# GLAST Large Area Telescope:

## AntiCoincidence Detector (ACD) WBS 4.1.6

# Summary of January Review

# Status of January Review Recommendations

**LAT-TD-00843-D1, Design Qualification Tests for ACD TDA and Phototubes**

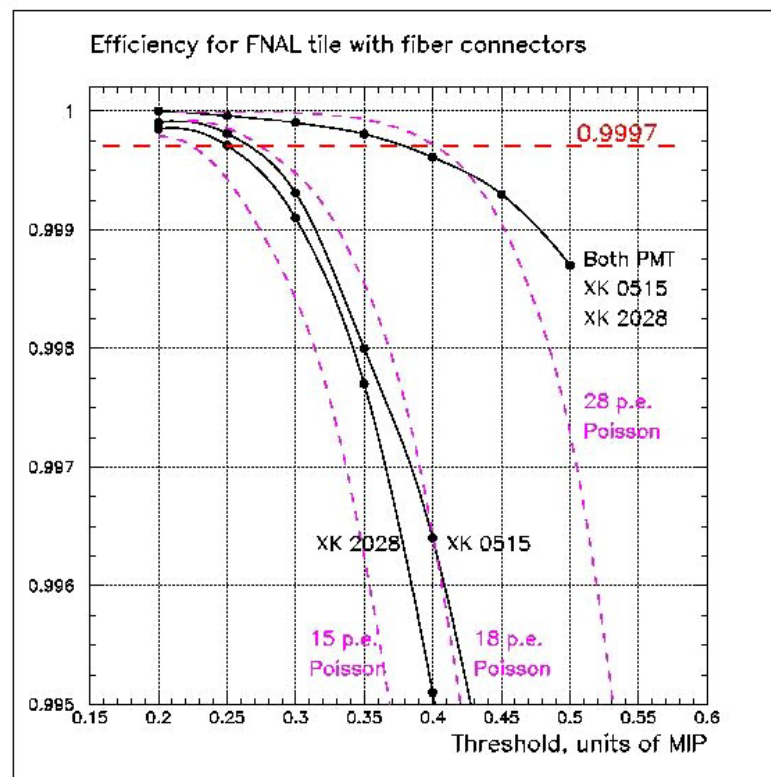
2. Perform light yield tests and muon detection efficiency measurement of the final optical system (scintillator tiles; and fiber ribbons, connector, clear fibers, and photomultiplier tubes).

Complete – results are similar to those shown in January: with two phototubes, 0.9997 efficiency is met; with one phototube, efficiency is  $\sim 0.999$

Light output of Fermilab tiles is good. Light losses in the optical connector and clear fibers are higher than expected. Further tests will be done to identify and improve the light loss.

**LAT-TD-00858-D1, ACD TDA  
Thermal Cycling Test**

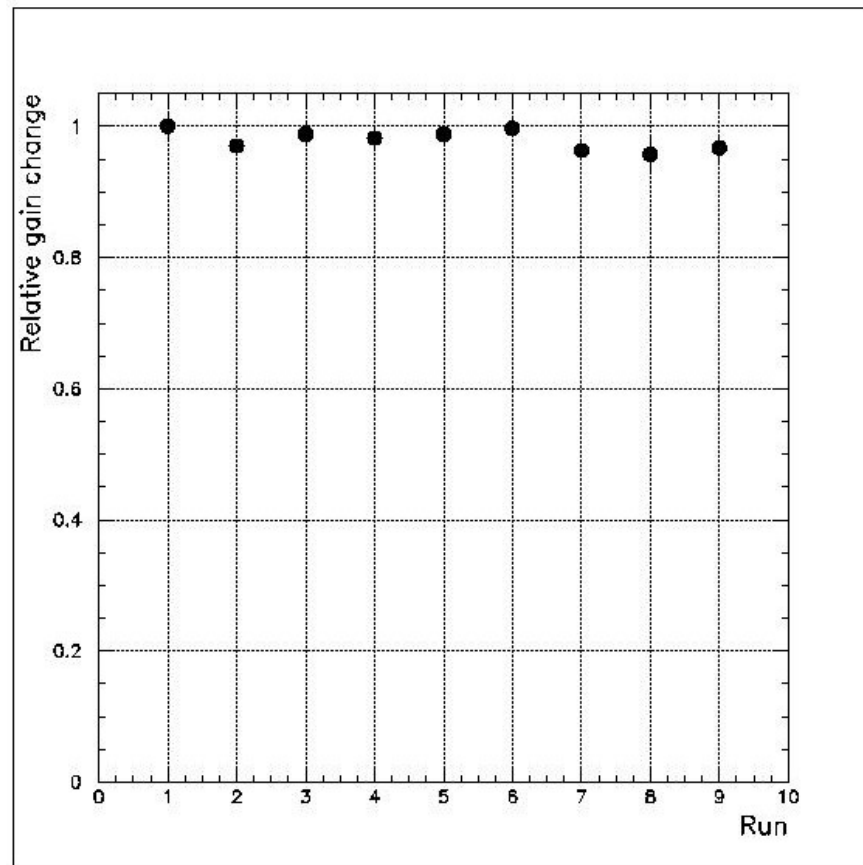
## 5. Perform thermal cycle of fully assembled tiles and ribbons. Verify that no damage to tile/fiber assemblies takes place and light yield is not decreased.

- Thermal cycle was -65 C to +45 C.
- Performance was measured using a muon telescope for Minimum Ionizing Particles.
- After 340 cycles, the loss of performance was less than 5%.
